Notice of Allowability

10/807,129

EXAMINER'S AMENDMENT

FIG. 4D

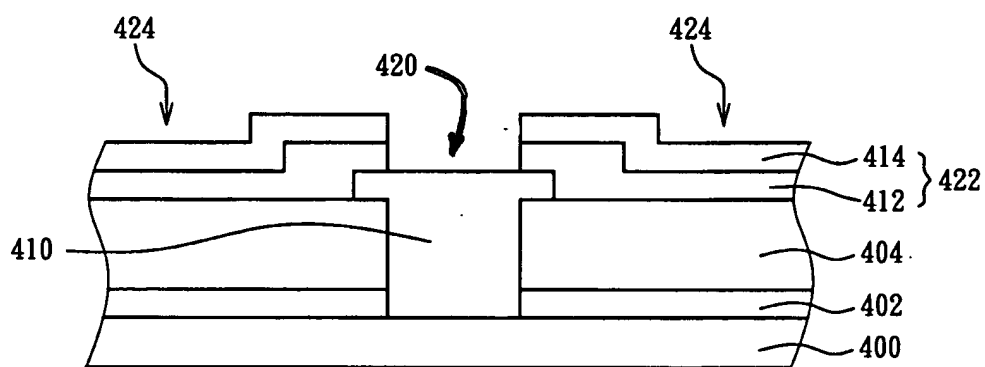
In the amended drawing sheet for Figure 4D, the arrow relating to element 420 was redirected to indicate the space, as opposed to the top layer (the layer is already labeled as 414). These changes were necessary to more properly coincide with the description of the invention, i.e. avoid confusion.

4. New corrected drawings in compliance with 37 CFR 1.121(d) are required in this application because of the indicated change made to Figure 4D. Applicant is advised to

In order to avoid abandonment of the application, applicant must make these above drawing changes.
